THE CITY OF WALTHAM
MASSACHUSETTS
PURCHASING DEPARTMENT
DESIGN, EXTERIOR CITY HALL

ADDENDUM NO. 2

Sept. 15, 2017

ITEM 2: DOMES/CUPOLA PICTURES

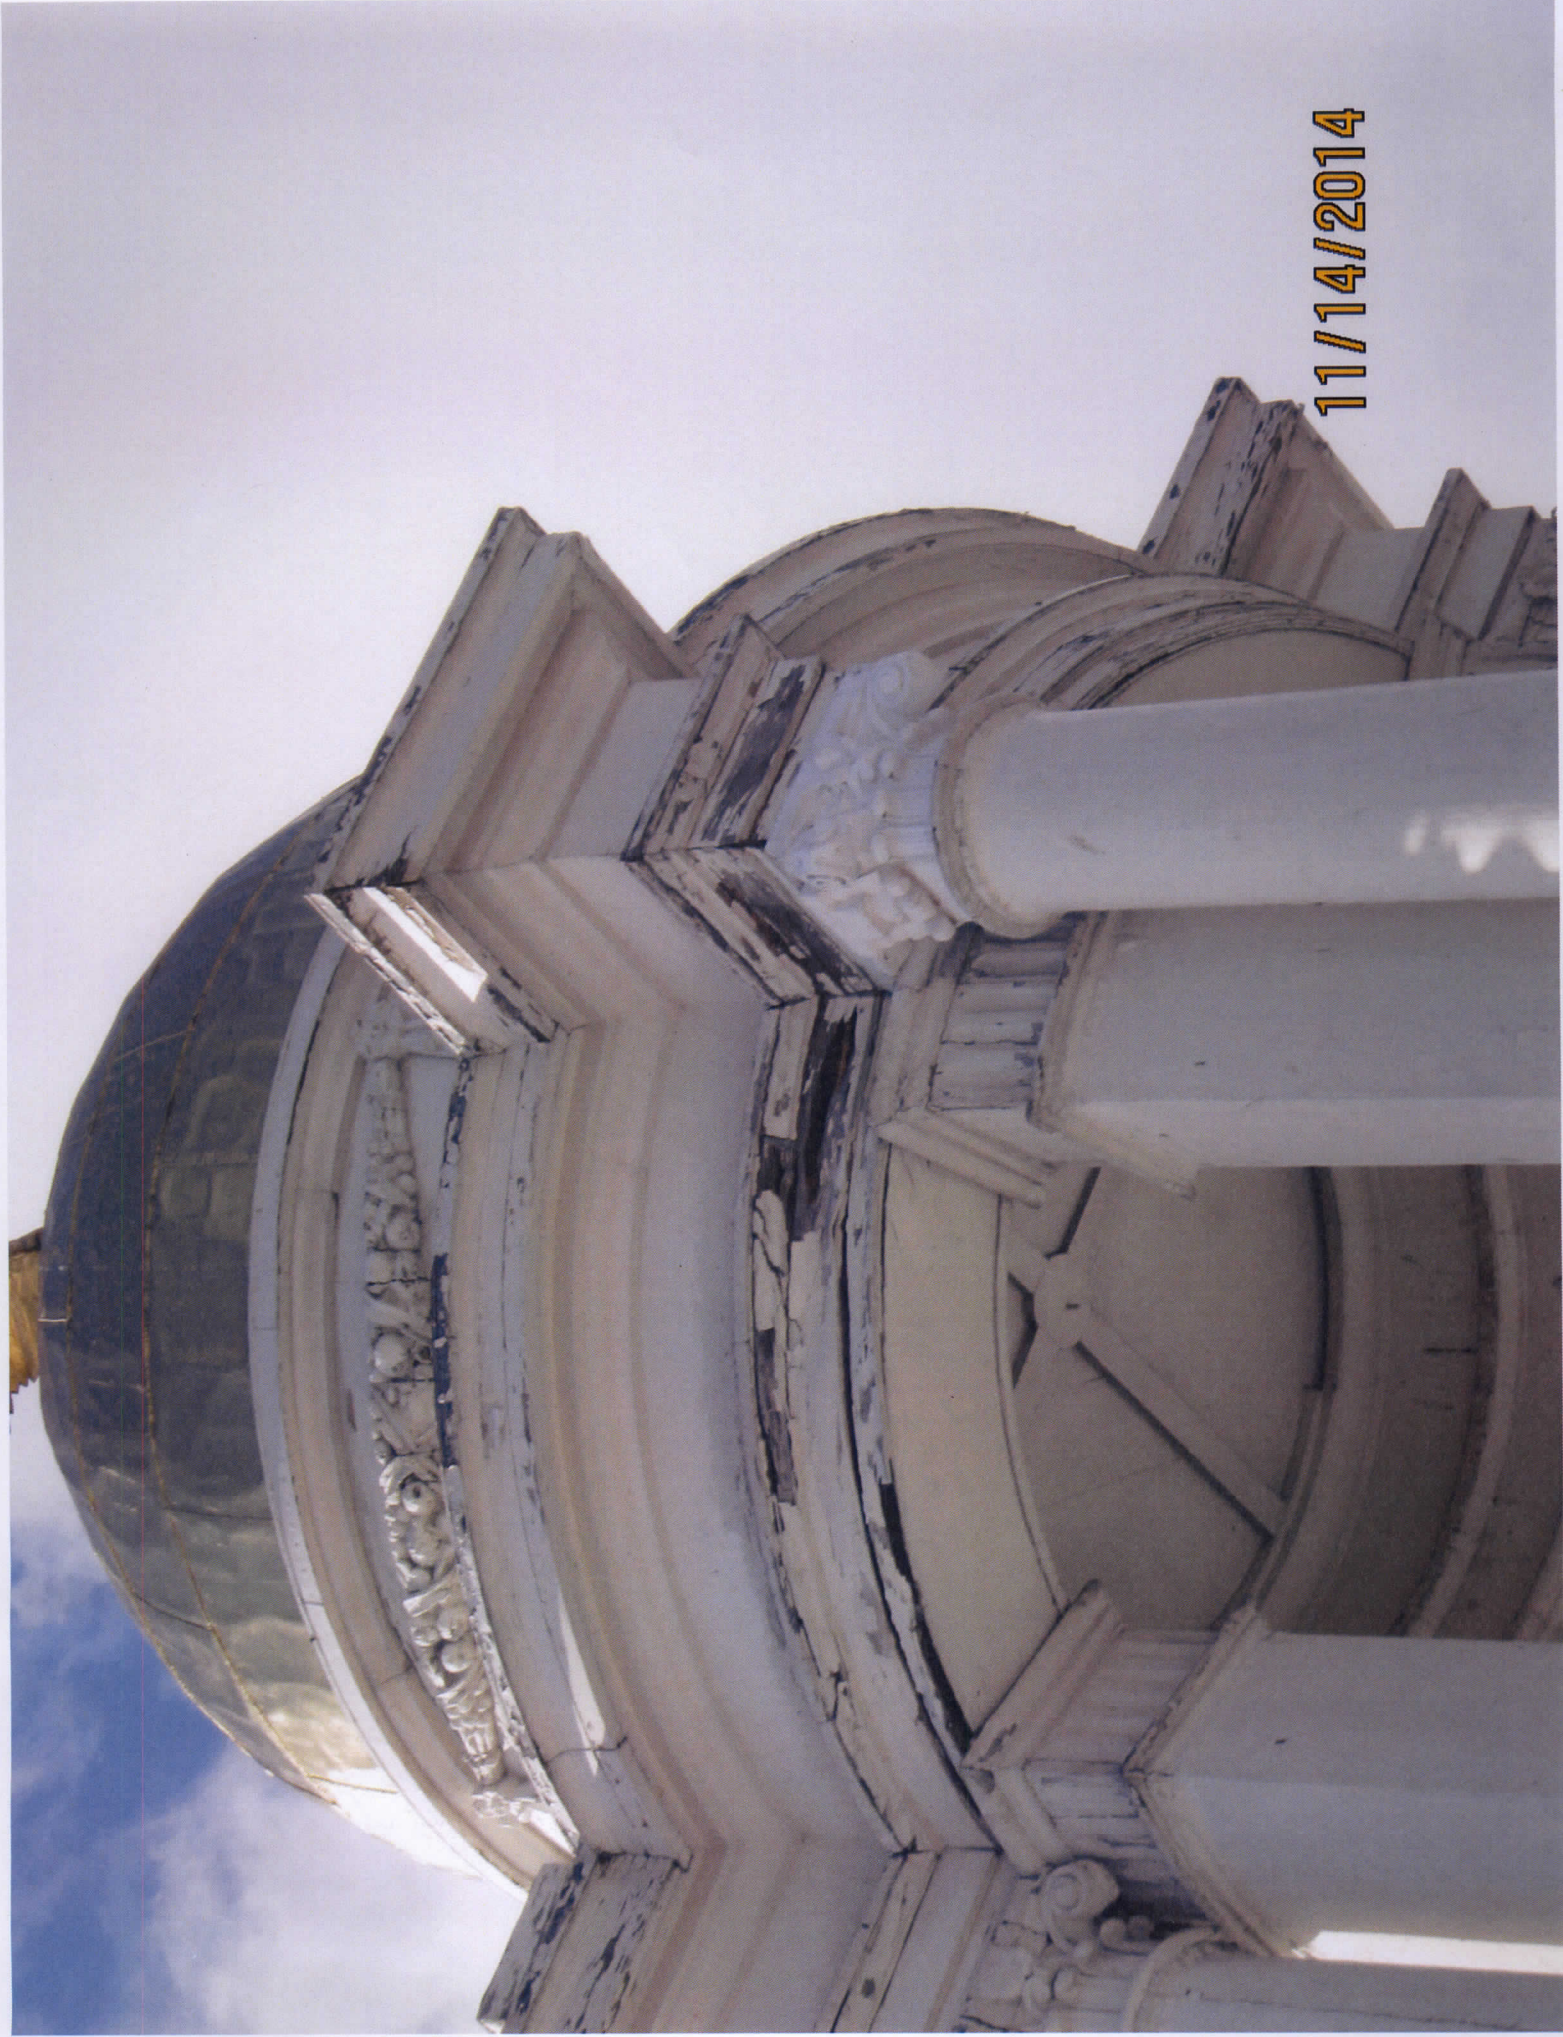
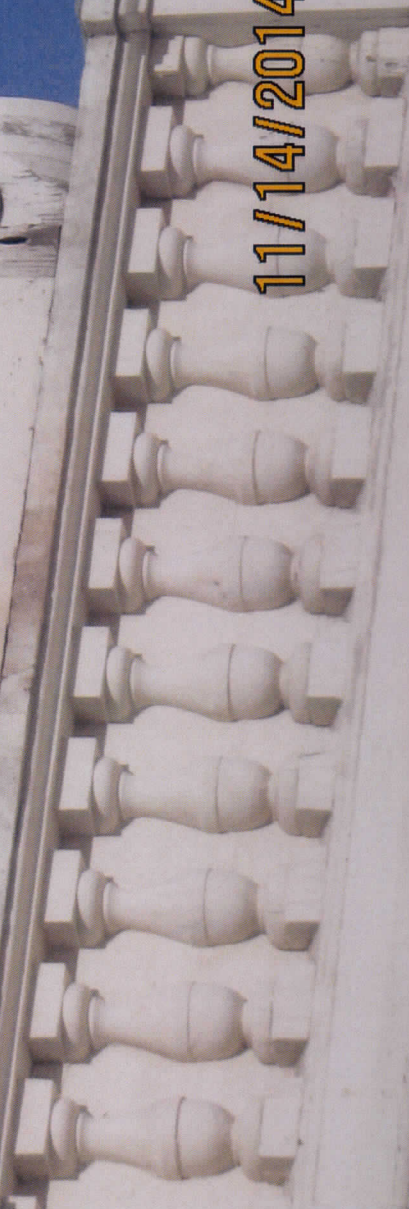
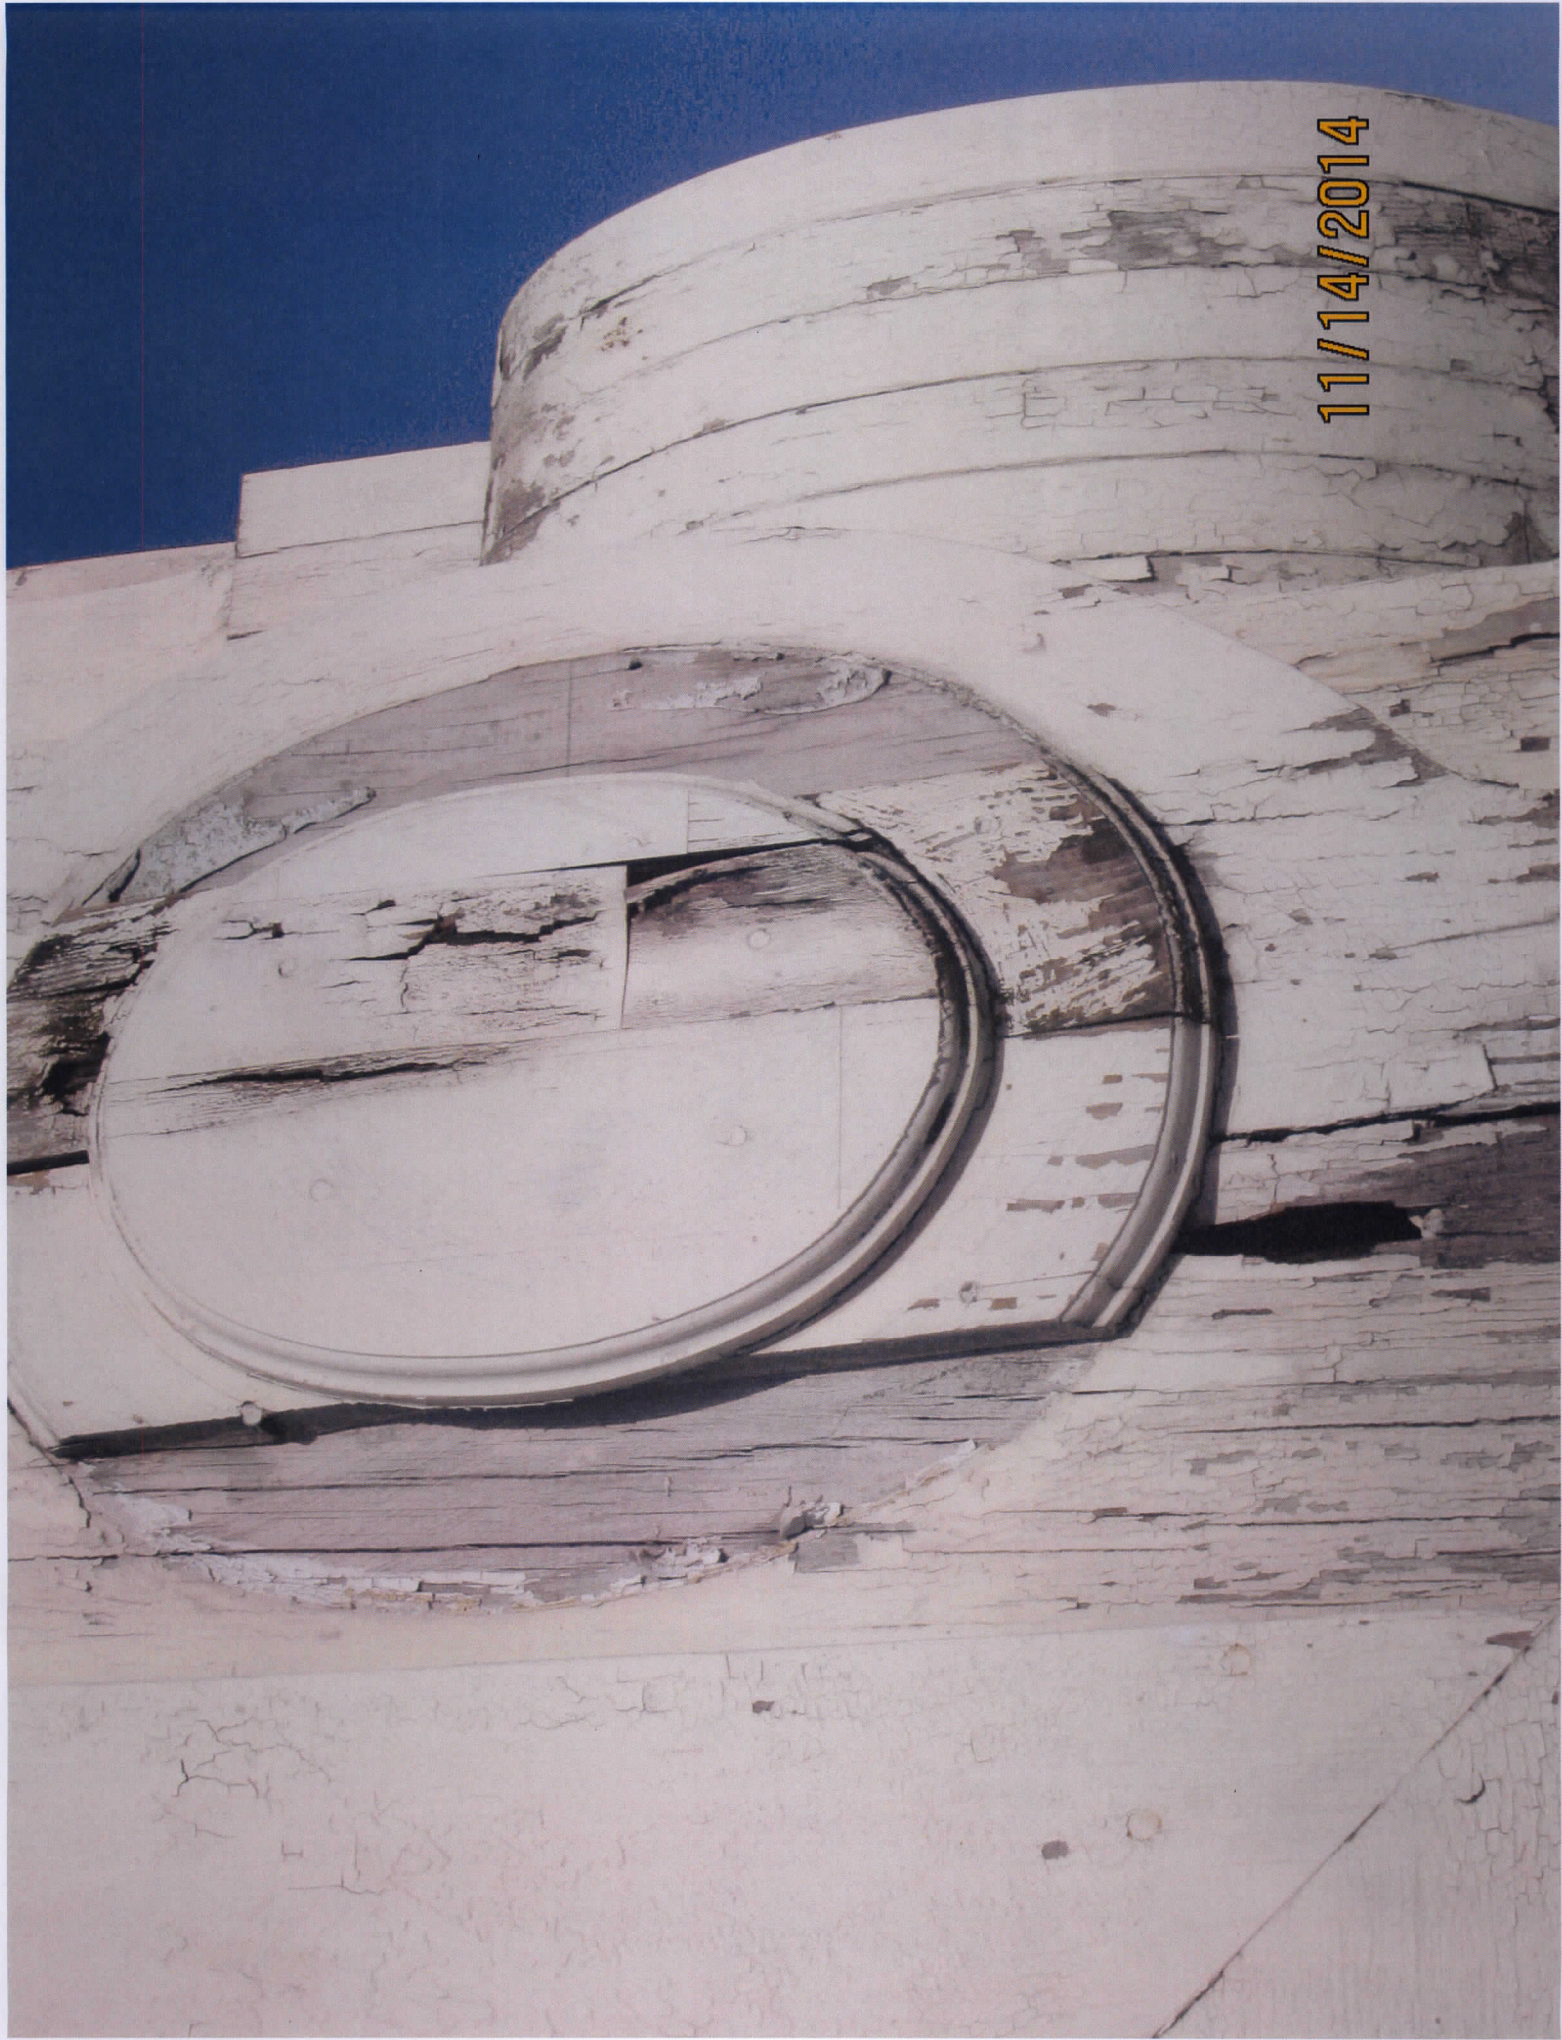
Question 4: Should access lift cost(s) be considered supplemental additional expense(s)?

Answer: The designer shall determine the need for the lift and absorb the cost. Also see the following dome pictures
